The Republic, Mayfield Manchester
Planning Addendum Report
0197_MAY-MCO-M01-XXXX-RP-A-090080
Rev: P03
Ref: A283-10.01-148
November 2024

1.0 Planning Addendum

1.1 Introduction

2.8 Eleventh Floor Plan

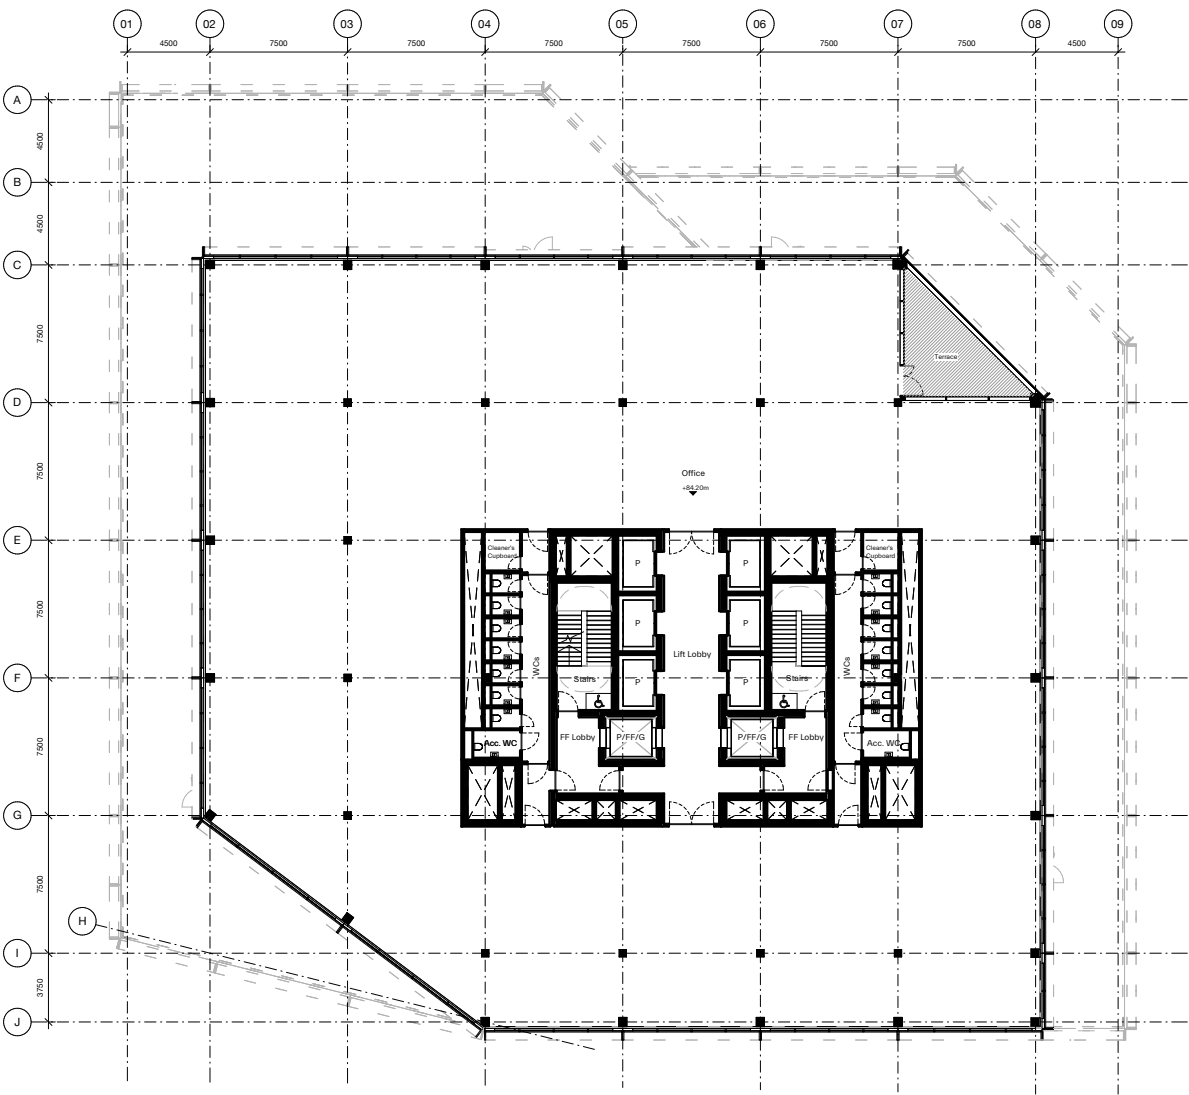
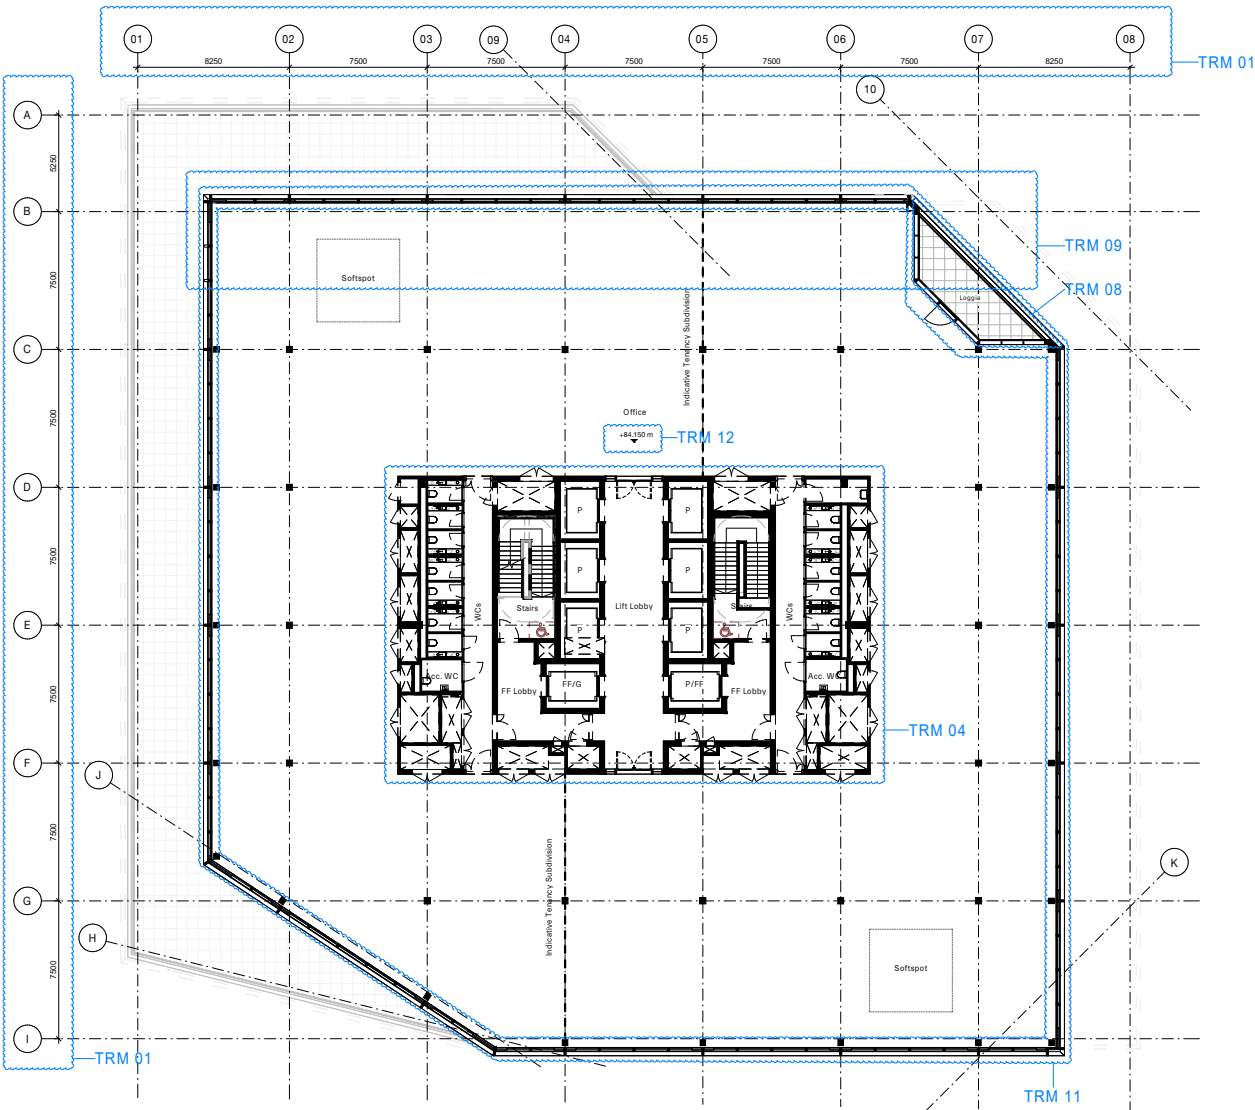
- + TRM 01 - Structural Grid
- + TRM 04 - Core Position
- + TRM 06 - External Doors
- + TRM 08- External Amenity Space
- + TRM 09 - Massing to North
- + TRM 11 - Facade Development
- + TRM 12 - FFL

2.9 Plant Plan

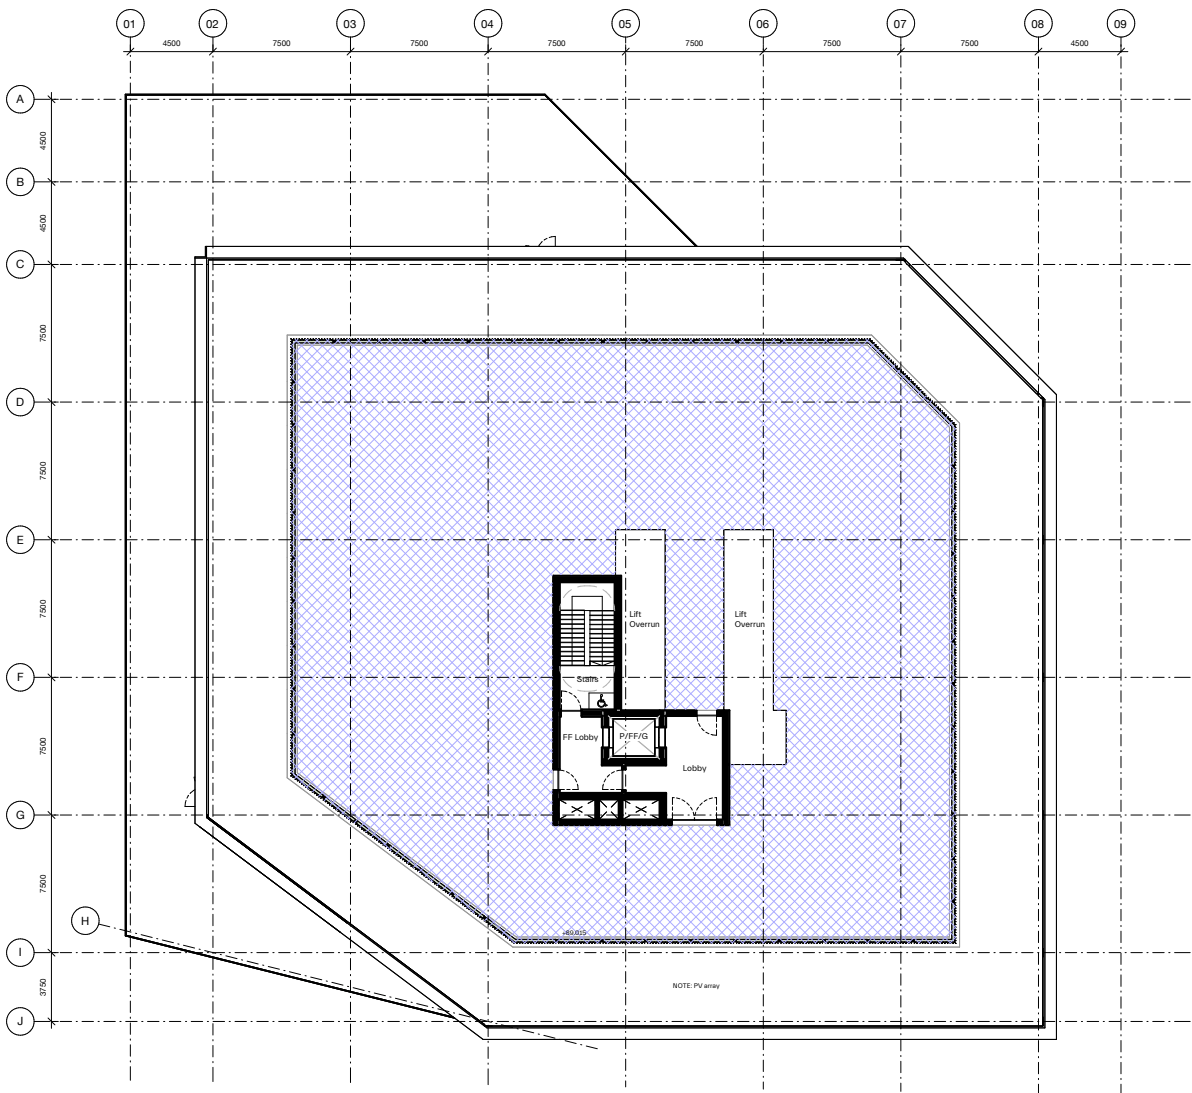
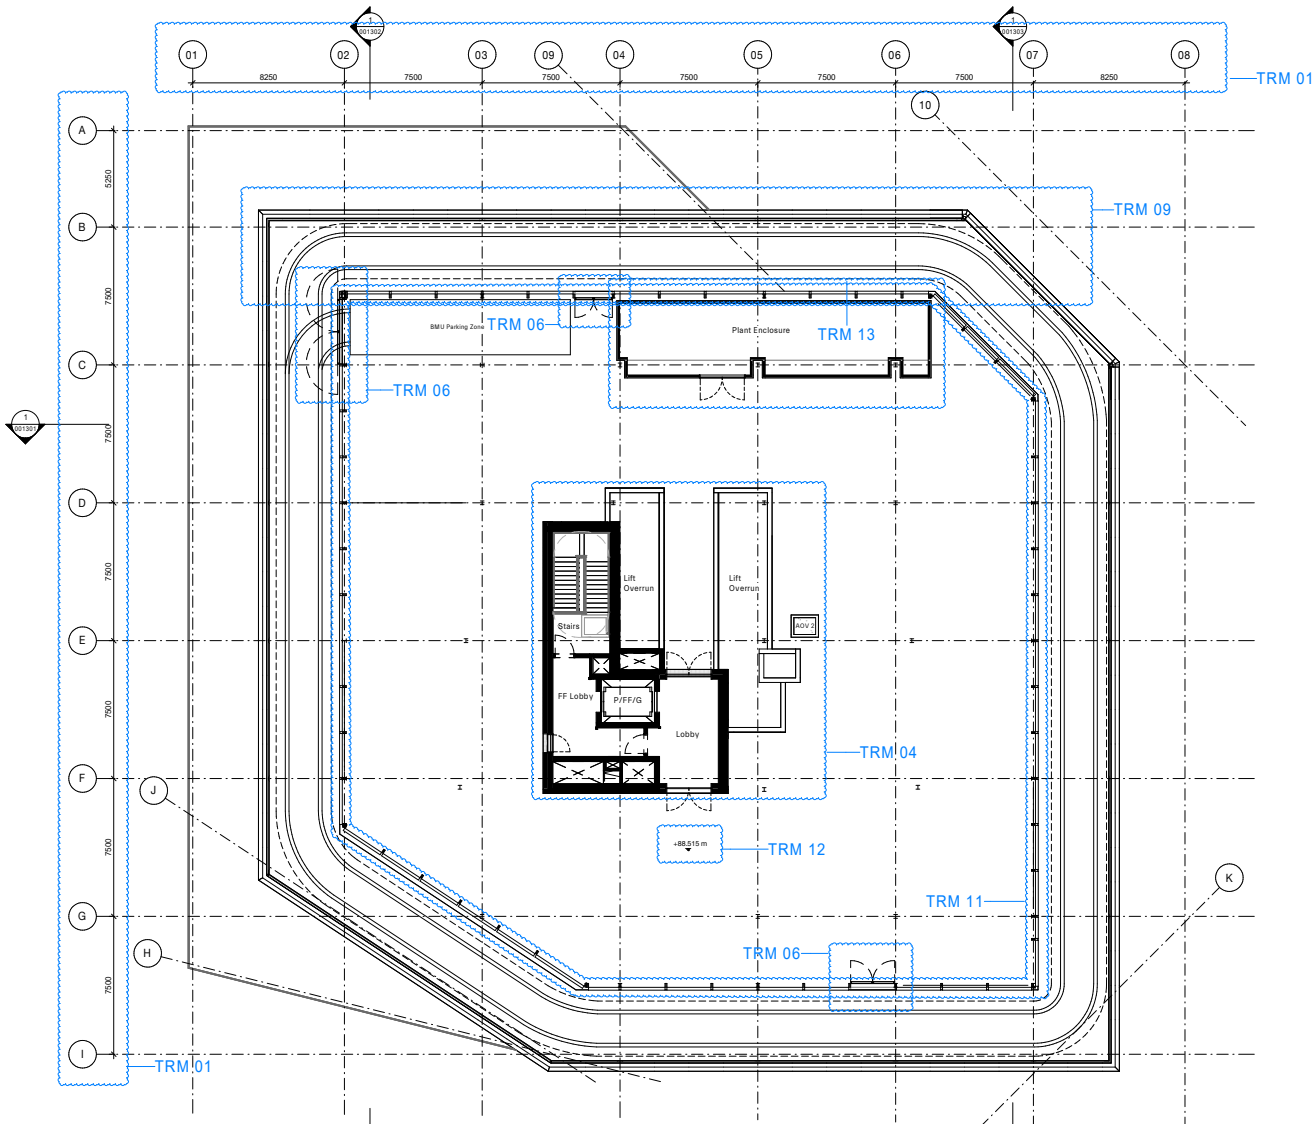
- + TRM 01 - Structural Grid
- + TRM 04 - Core Position
- + TRM 06 - External Doors
- + TRM 09 - Massing to North
- + TRM 11 - Facade Development
- + TRM 12 - FFL
- + TRM 13 - Plant Enclosure

2.10 Roof Plan

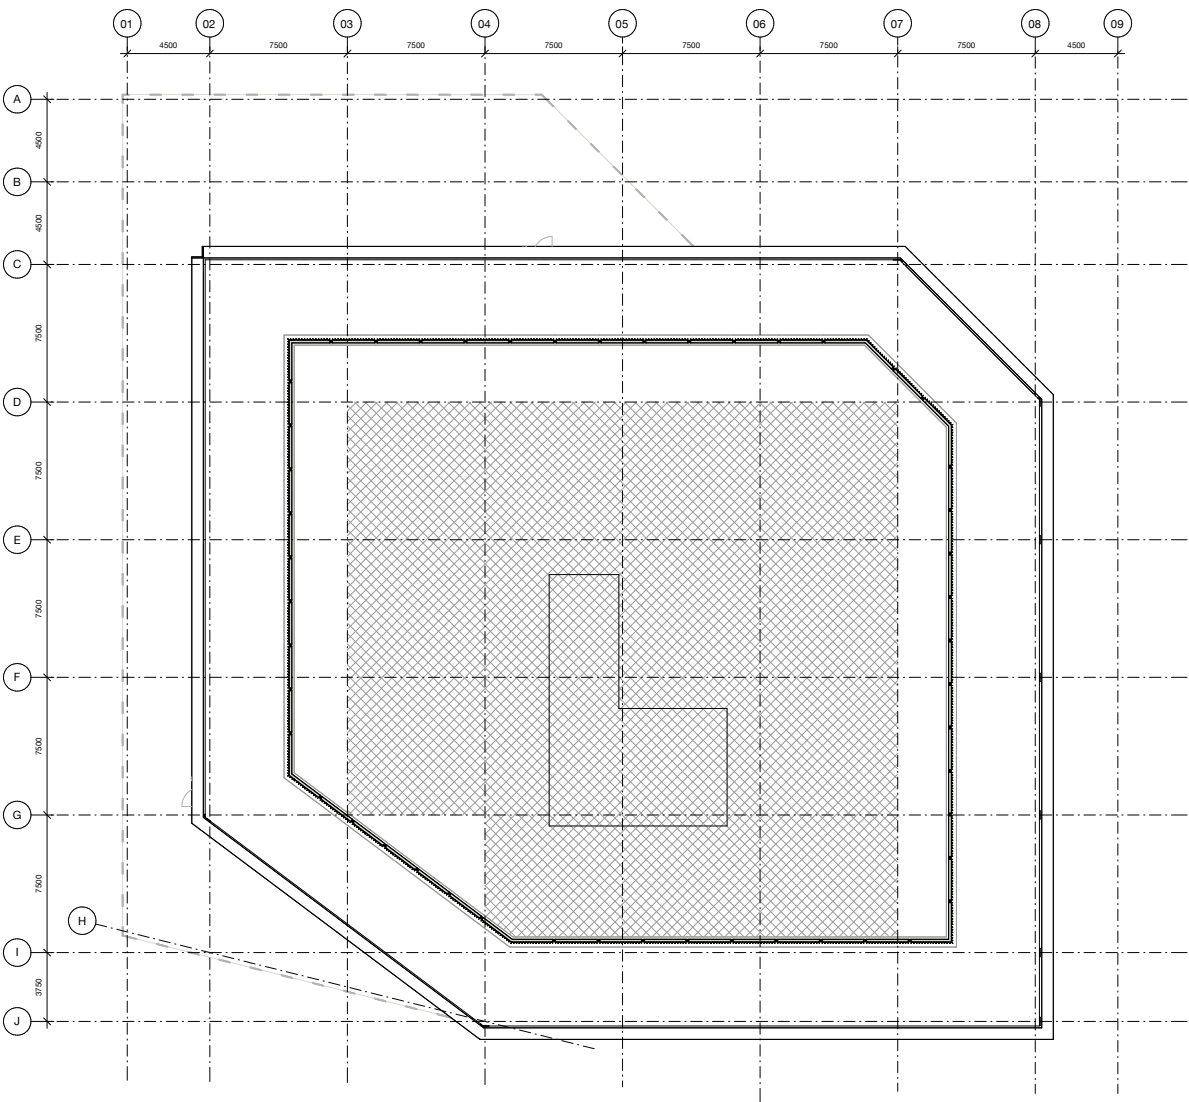
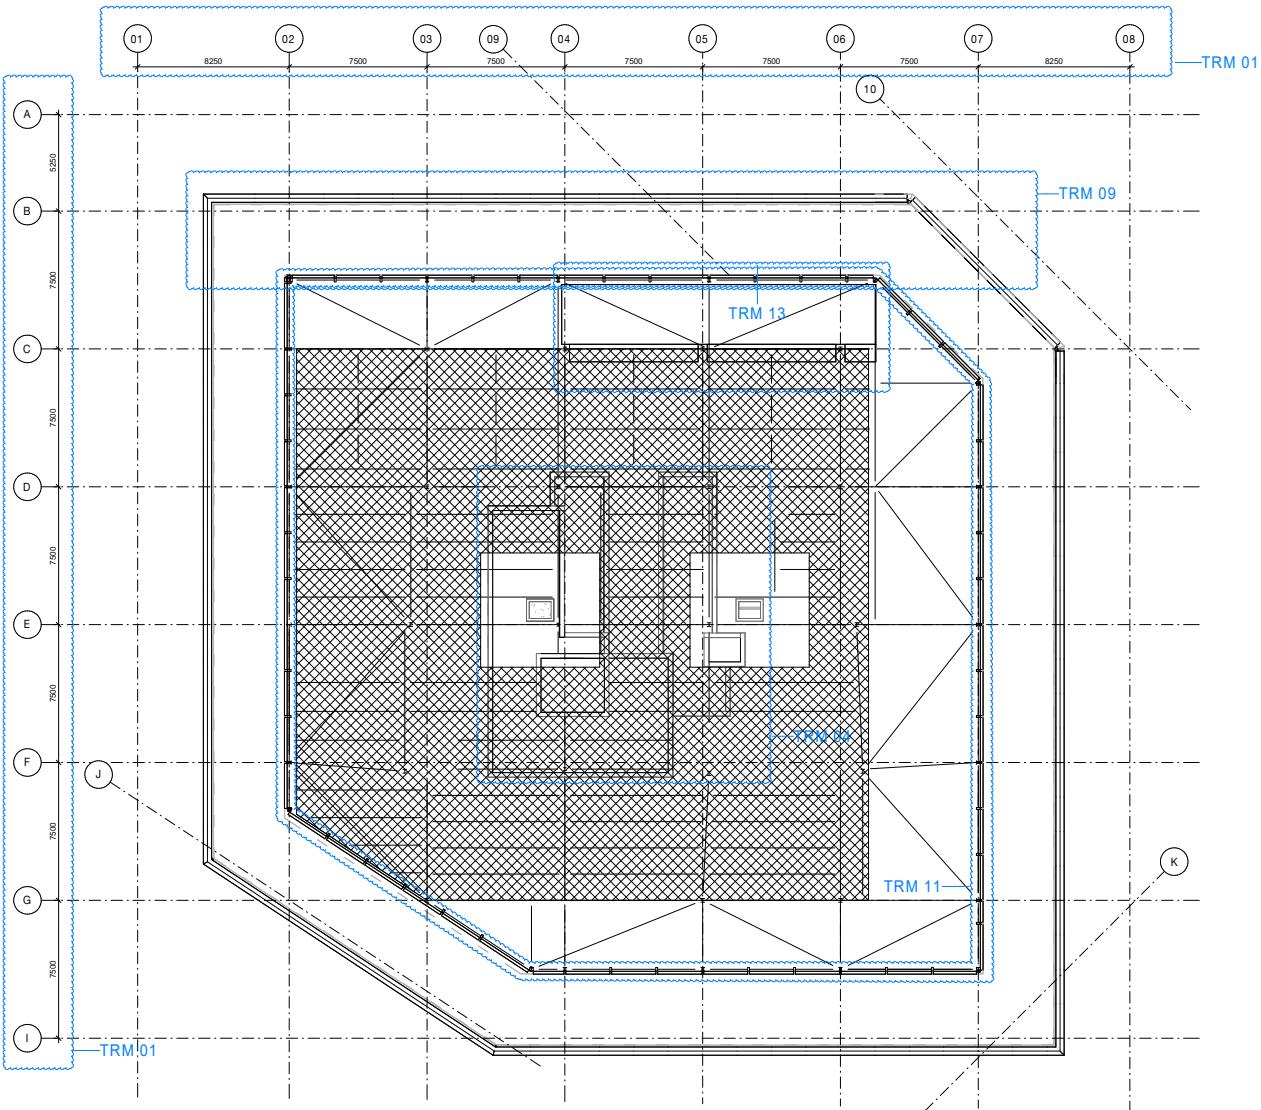
- + TRM 01 - Structural Grid
- + TRM 04 - Core Position
- + TRM 09 - Massing to North
- + TRM 11 - Facade Development
- + TRM 13 - Plant Enclosure
